## Groundwater Review Summary Form

Application # G- 18311-RR

PUBLIC INTEREST REVIEW FOR GROUNDWATER APPLICATIONS

SUBJECT: Application G- 18311 Supersedes review of October 31, 2016\*\*  
Date of Review(s)

Stream-depletion Model Results

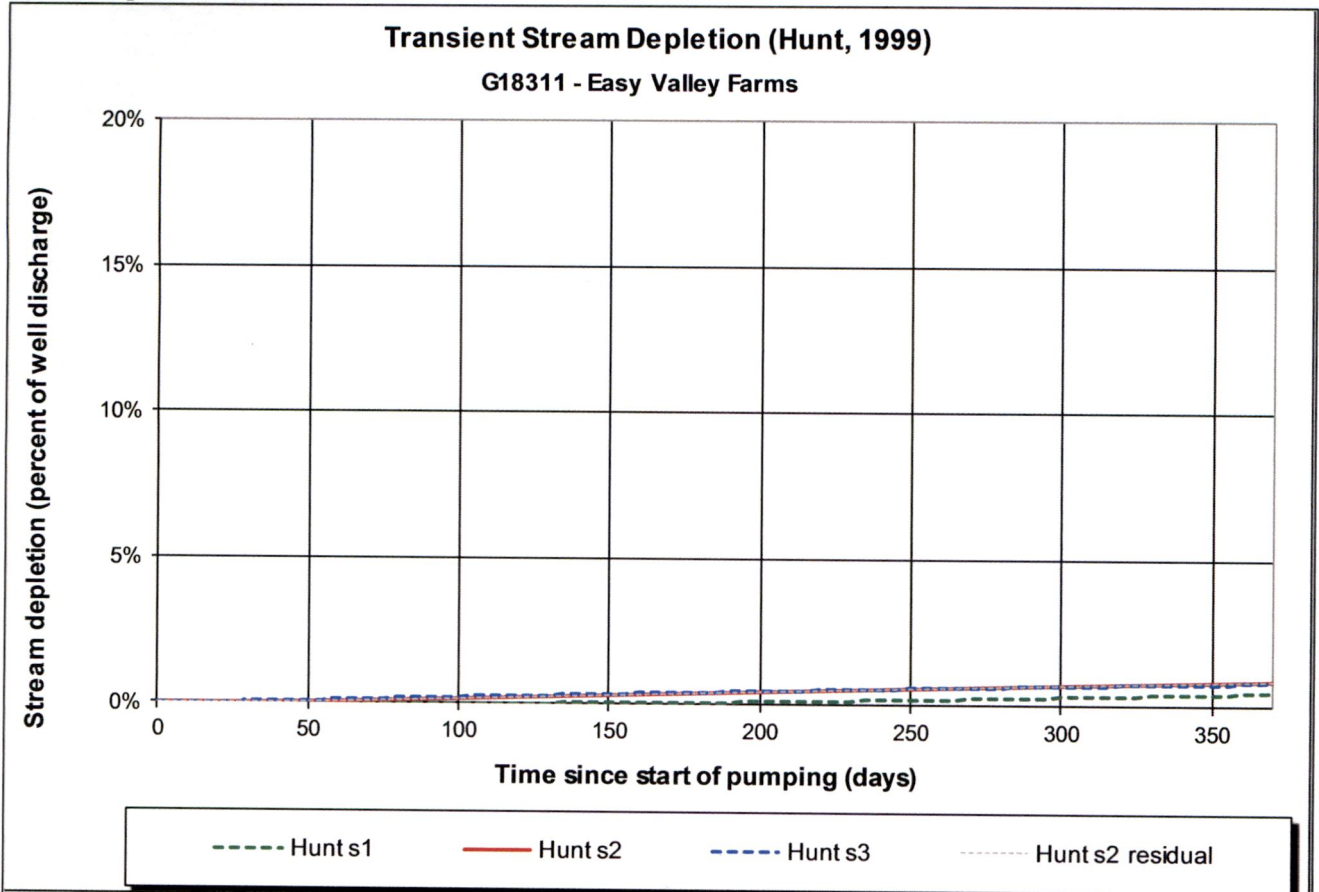
**Comments:** Interference @ 30d was estimated using the Hunt (1999) analytical stream-depletion model. Model results for SW #2 are attached below.

C6. **SW / GW Remarks and Conditions:** The review found that the applicant's proposed POA would be producing from an unconfined aquifer and is within 1 mile of Evans Creek (a perennial stream with two instream water rights and many surface water PODs). Calculated interference (i.e., stream-depletion) with Evans Cr. is below 1% after 30 days of pumping and so an assumption of PSI cannot be made.
